POLICY REPORT
DEVELOPMENT AND BUILDING

TO: Vancouver City Council
FROM: Director of Planning
SUBJECT: CD-1 Text Amendment - 2803 West 41st Avenue (Crofton Manor)

Figure 10: Parking

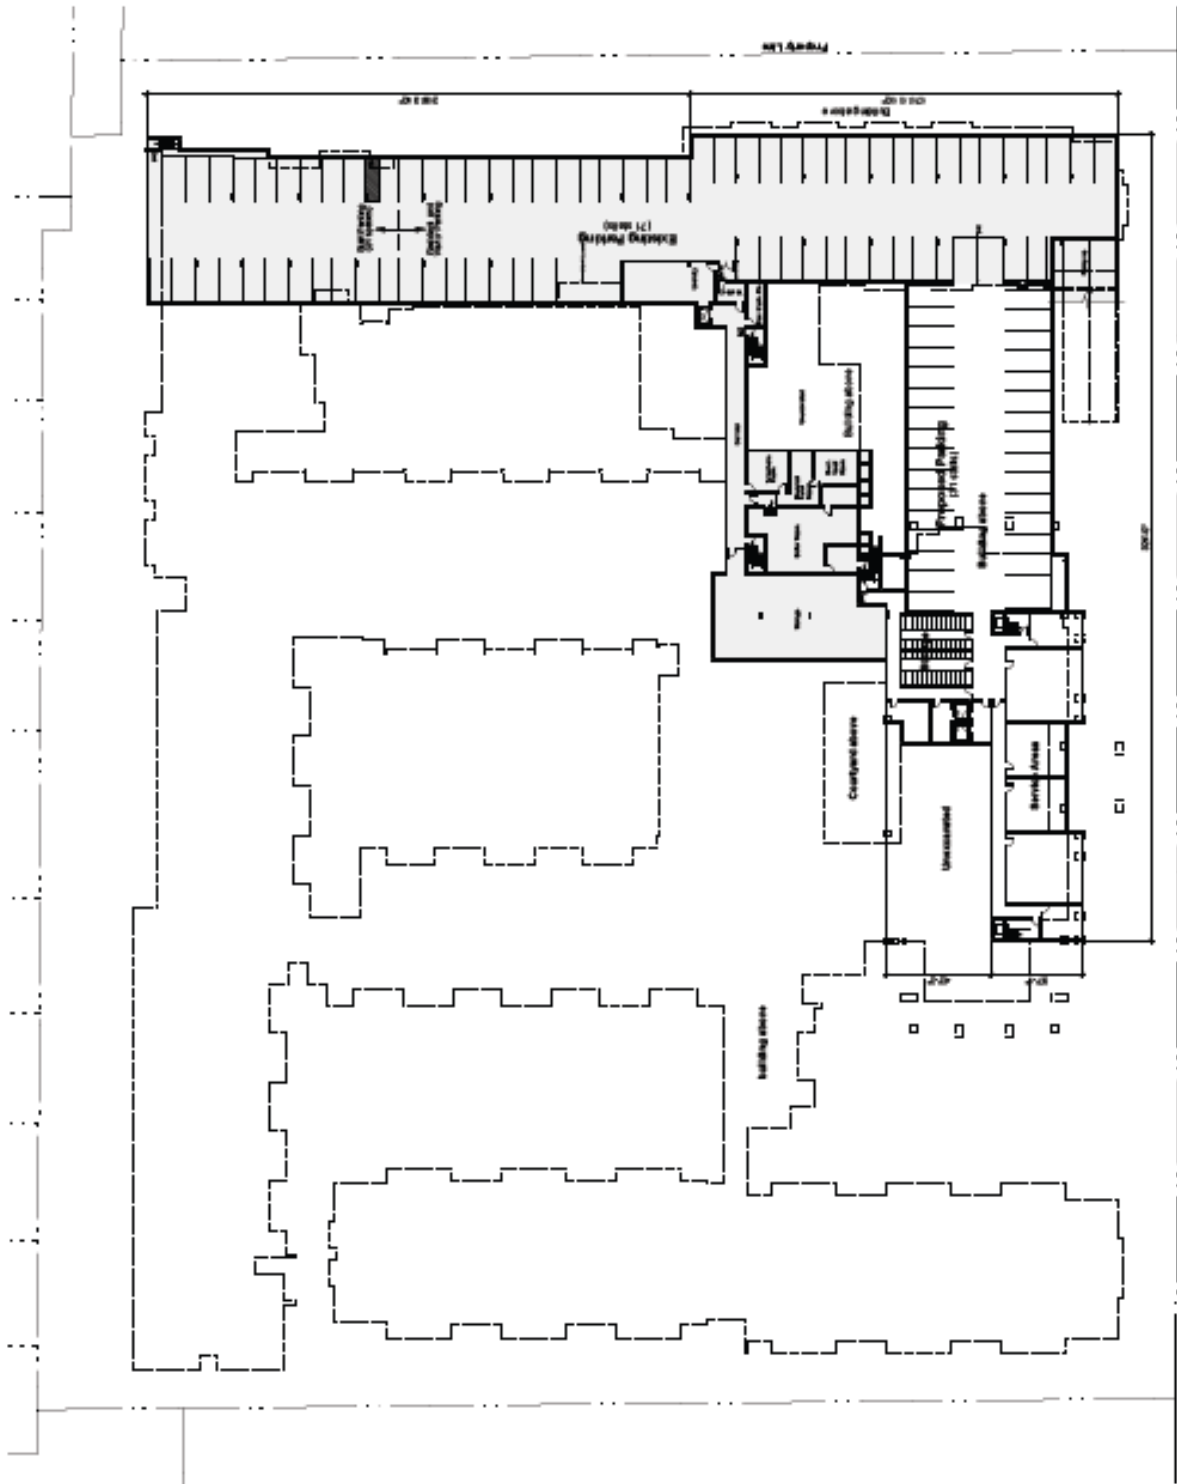
- 18. provide a minimum of 0.25 handicap scooter parking spaces per bed;
- 19. number all parking stalls and label stalls as either standard, small car or disability;
- 20. clarify total number of parking spaces being provided;

Note to applicant: tech table states 140 spaces and count on drawing shows 114.

- 21. provide design elevations for all new proposed parking area (surface and underground), drive aisle and on both sides of the existing ramp and new access ramp at all breakpoints to be able to calculate slope and crossfall;

- 22. provide a bicycle wheel ramp for the stairway from the parking level to the main floor;
- 23. provide an improved Ground Floor Plan (A 101) and overall Parking Floor Plan (A103) at 1:200 or 1/16":1' scale;

Note to applicant: it appears that there is a disability space in the new proposed parking area and vertical clearance at the transition from the existing parking to the proposed parking area measures 7' on section drawing A-401.

27. confirm that there are no support columns in the new proposed underground parking area and no building overhang to restrict the vertical clearance of the loading bay;
28. relocate the tree shown on plan L-1.2 next to the drive aisle accessing the loading bay as it is encroaching into the drive aisle and parking space;
